P-19-20

Petition Summary

Request for approval of an amendment to the Planned Unit Development (PUD) for Lane Parke.

DRIVE-THROUGH QUEUE TRAFFIC STUDY

Figure 1. Drive-Through Locations

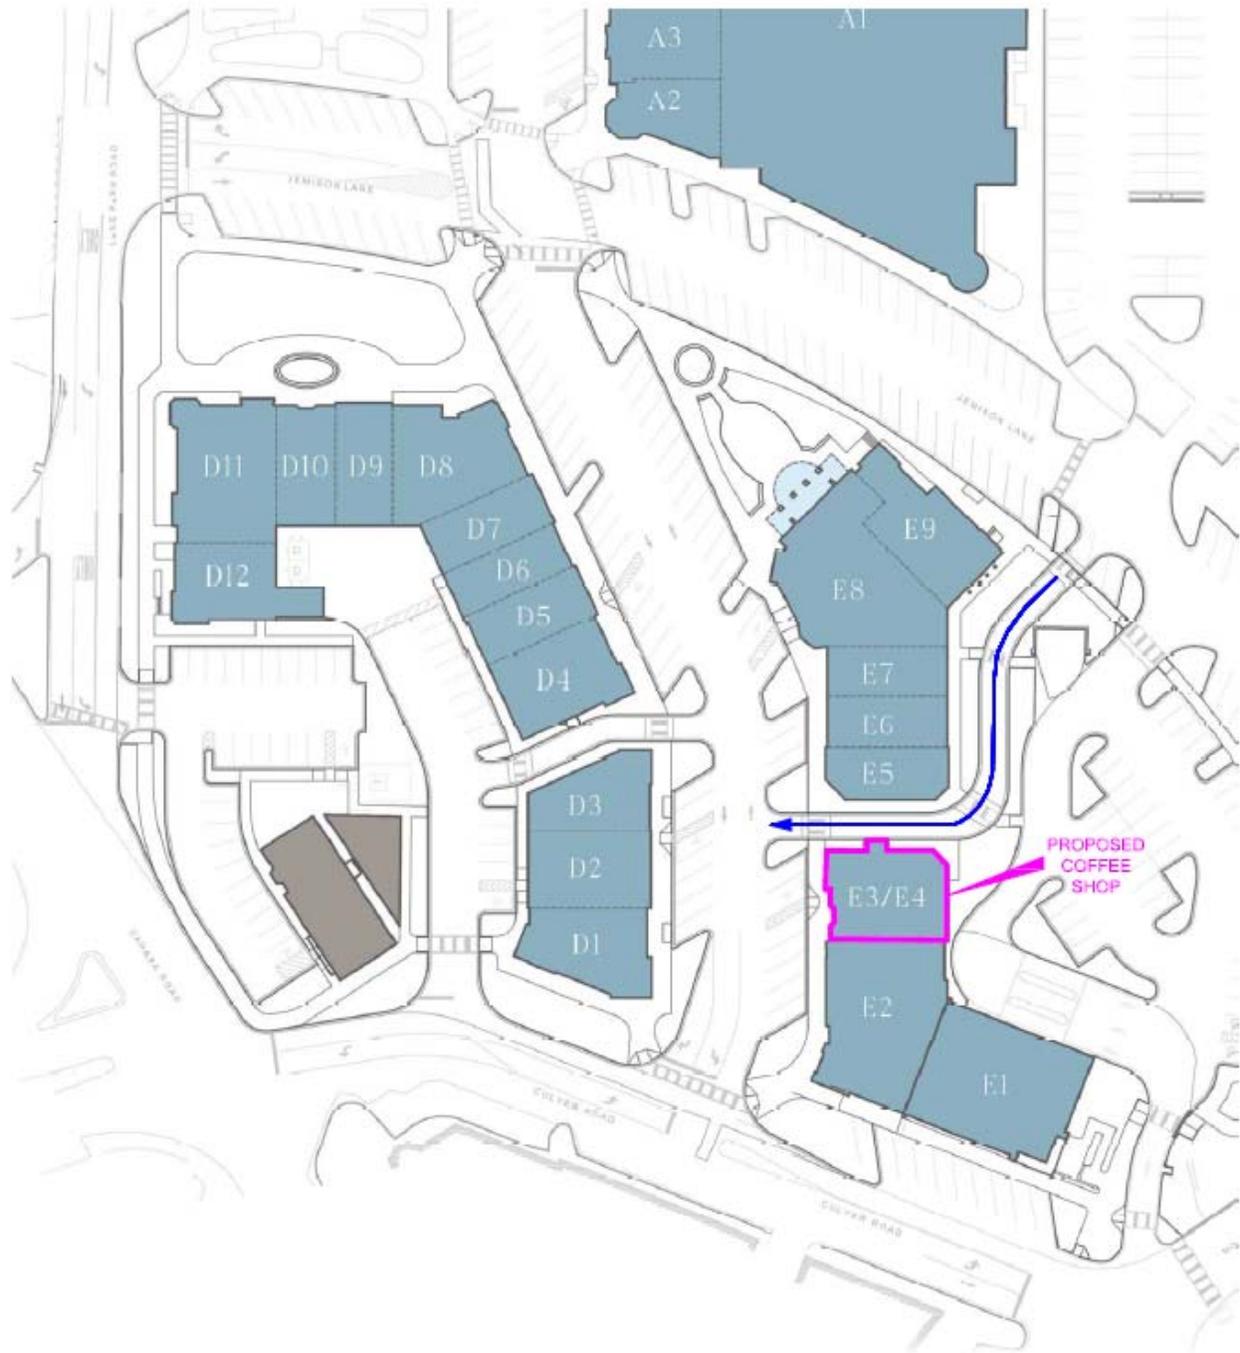
This report documents a traffic analysis to support a change in the Lane Parke PUD in Mountain Brook, Alabama, in order to allow construction of a drive-through window for a proposed Coffee Shop. The proposed shop location within the PUD and orientation of the drive-through lane is shown in Figure 1.

The drive-through lane for the Coffee Shop has the capacity to store approximately nine (9) vehicles beginning at the window, before the queue blocks the crosswalk crossing the entrance to the drive-through lane. The length of available storage is 195 feet, and the assumed queue per stored vehicle is 22 feet, on average.
